Technical Service Bulletin

Tennant T5 ec-H2O

ec-H2O module inlet hose kinking causing a false scaling detection (*ec-H2O* system indicator light blinks red and alarm sounds).

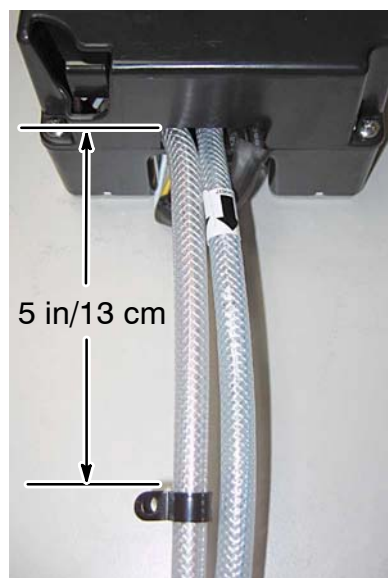
To prevent hose from kinking, install clamp p/n 140328 as described below.

Add Clamp p/n 140328

Position clamp on inlet
hose as shown

Attach clamp to Module.
